DEPARTMENT OF THE ARMY  
CORPS OF ENGINEERS, PORTLAND DISTRICT  
PO BOX 2946  
PORTLAND OR 97208-2946

On June 9, 2016, the Environmental Protection Agency (EPA) issued the Proposed Plan (Plan) for the remediation of the Portland Harbor Superfund Site for public comment through September 6, 2016. The U.S. Army Corps of Engineers Portland District (Corps) has reviewed the document and is providing comments on the Plan and supporting Feasibility Study with this letter.

**Table 1.** Corps of Engineers, Portland District comments on the proposed Plan/Feasibility study for cleaning up the Portland Harbor Superfund Site.

Figure 1.2-14a. Distribution of Surface Sediment Chemistry for Arsenic

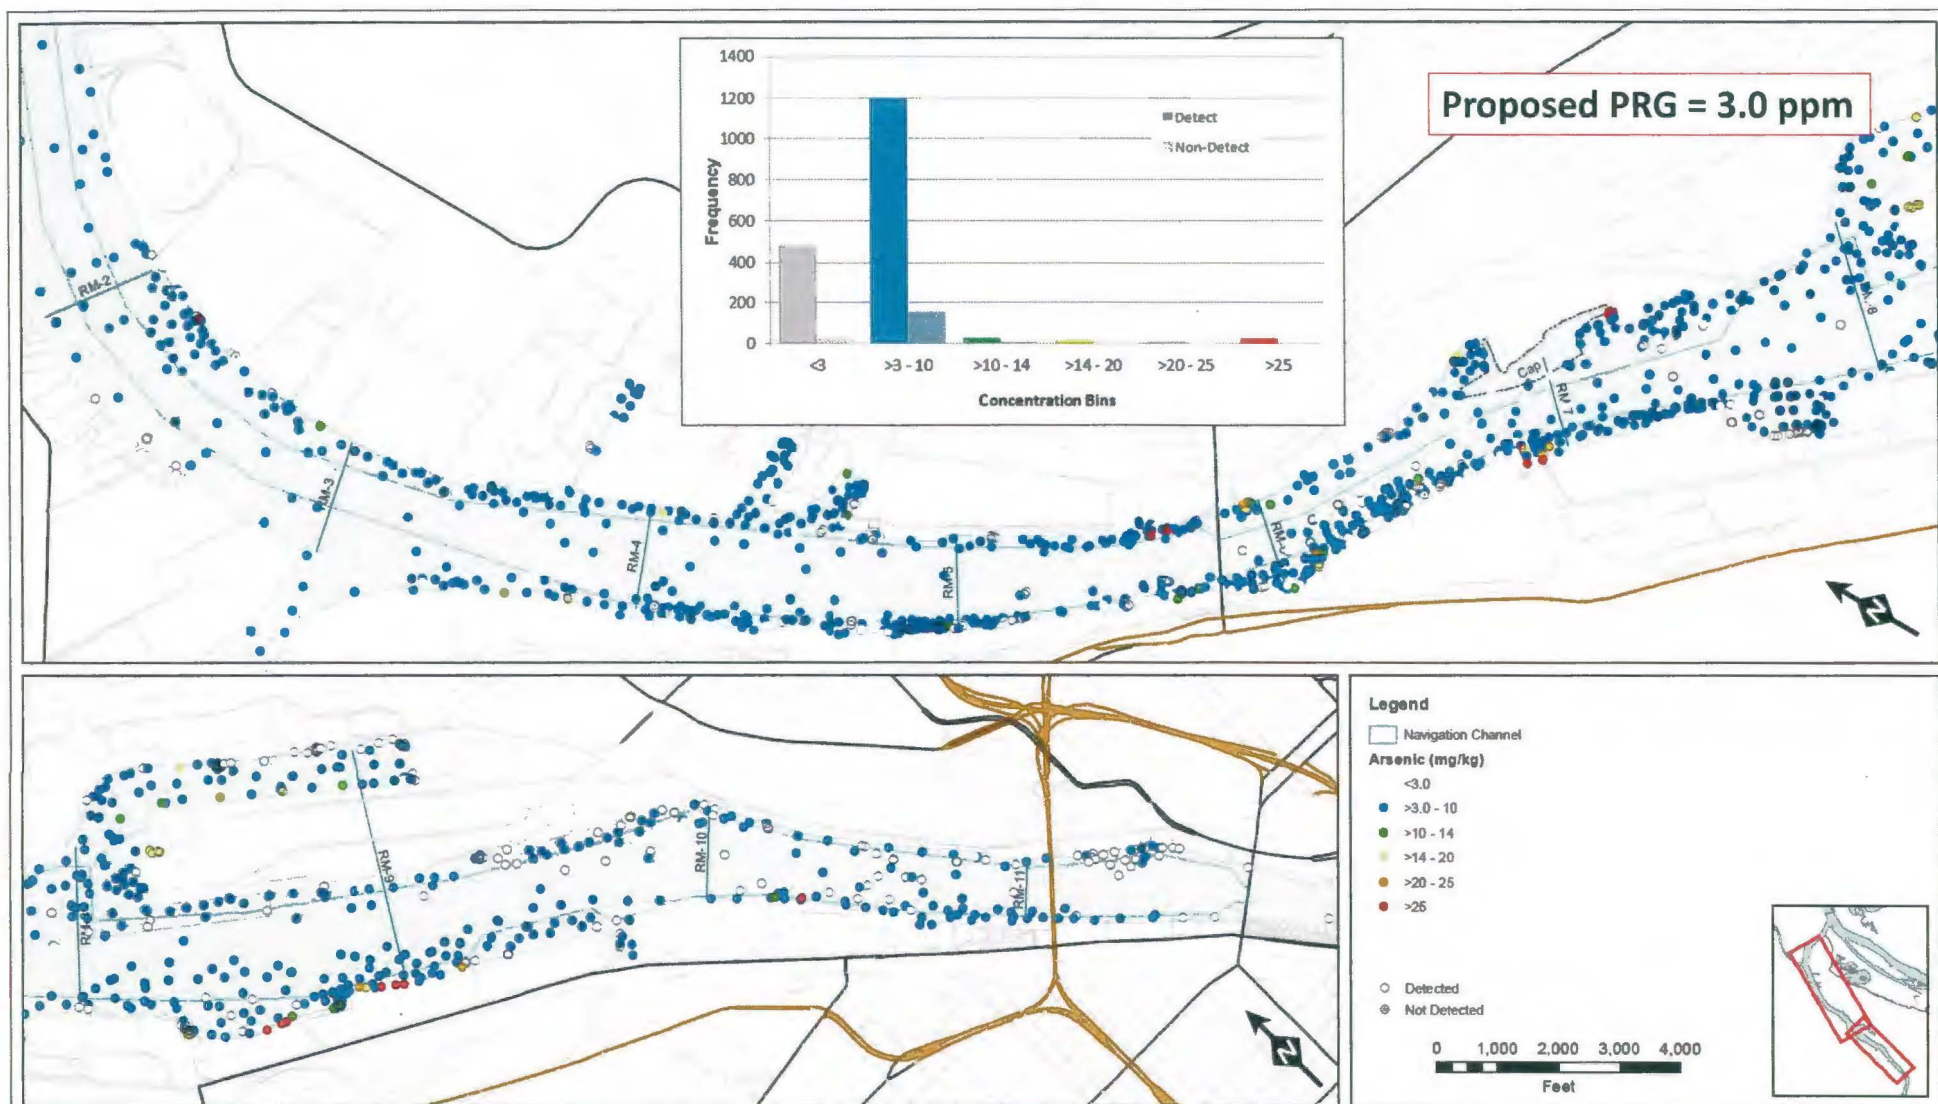
Sediment Quality	Feasibility Study	Figures 1.2-6a/b to 1.2-18a/b	<p>Figures 1.2-6a/b to 1.2-18a/b of the Feasibility Study provide clear, visual evidence that EPA's proposed PRGs are unattainable. Most of these figures show chemical concentrations above the proposed PRGs distributed throughout the non-cleanup portions of the Harbor (Attachment B). With low-level concentrations of contaminants so broadly distributed throughout the Harbor, and outside of proposed sediment management areas, please explain how the proposed PRGs will be achieved in a reasonable timeframe.</p>

Discipline/ Area of Interest	Document	Document Location	Comment
			<p>E.g., EPA's proposed PRG for total PCBs is 9.0 ppb. Out of approximately 1,200 detected results, approximately 600 surface sediment samples have total PCBs concentrations ranging from &gt;9 to 50 ppb; many of which are outside of proposed sediment management areas. Another 400 samples show total PCBs concentrations ranging from &gt;50 to &gt;1,000 ppb. Only 200 samples had total PCBs concentrations at 9 ppb or less. Therefore, how does EPA expect to achieve a remedial goal of 9 ppb or less, when 83% of the surface sediment distributed throughout the Harbor contains concentrations greater than 9 ppb total PCBs, and only 50% of the surface sediment <u>in non-cleanup areas</u> ranges from 9 to &lt;50 ppb?</p> <p>EPA's proposed PRG for arsenic is 3 ppm. Approximately 1,200 surface sediment samples have arsenic concentrations ranging from &gt;3 to 10 ppm and less than 100 samples are above 10 ppm; many of these points are outside of proposed sediment management areas. Approximately 450 points are &lt;3 ppm. How does EPA expect to achieve a remedial goal of 3 ppm or less, when most of the sediment outside of proposed sediment management areas ranges from 3 to 10 ppm?</p>

Sediment Quality	Feasibility Study	Figures 1.2-6a/b to 1.2-18a/b	EPA has developed proposed PRGs for most of the compounds depicted in these figures. The break between the lowest concentration group and the next-lowest concentration group needs to be the same as the PRG. For example, in Figures 1.2-11a/b (total chlordanes), the lowest concentration grouping ranges from 0 ppb (non-detect) to 1.5 ppb, and the next grouping ranges from >1.5 to 5.0 ppb. However, the proposed PRG for total chlordanes is 0.5 ppb. Please modify these figures (and the inset bar graph) with the break between the lowest concentration group and the next-lowest concentration group set at 0.5 ppb.
Sediment Quality	Feasibility Study	Figures 1.2-7a/b	Since EPA has developed draft PRGs for multiple PCDD/F congeners (2,3,7,8-TCDD; 2,3,7,8-TCDF; 1,2,3,7,8-PeCDD; 2,3,4,7,8-PeCDF; and 1,2,3,4,7,8-HxCDF), please prepare separate figures showing the surface/subsurface concentrations of each congener.

Sediment Quality	Feasibility Study	Figures 1.2-9a/b	Since EPA has developed a draft PRG of 12 ppb for total cPAHs (BaP equivalent), please prepare a separate figure showing the surface/subsurface concentrations of total cPAHs with the first break at 12 ppb. This exercise will also illustrate the unattainability of this proposed PRG.
Sediment Quality	Proposed Plan/ Feasibility Study	General comment	EPA's handling of non-cleanup areas within Superfund study areas is inconsistent within Region 10. In coordination with EPA Cleanup, the interagency Washington Dredged Material Management Program (DMMP) has been allowed to evaluate routine maintenance dredging projects in the Lower Duwamish Waterway (LDW) using the guidelines published in the 2016 SEF. It is our understanding that EPA required that contaminant concentrations in the
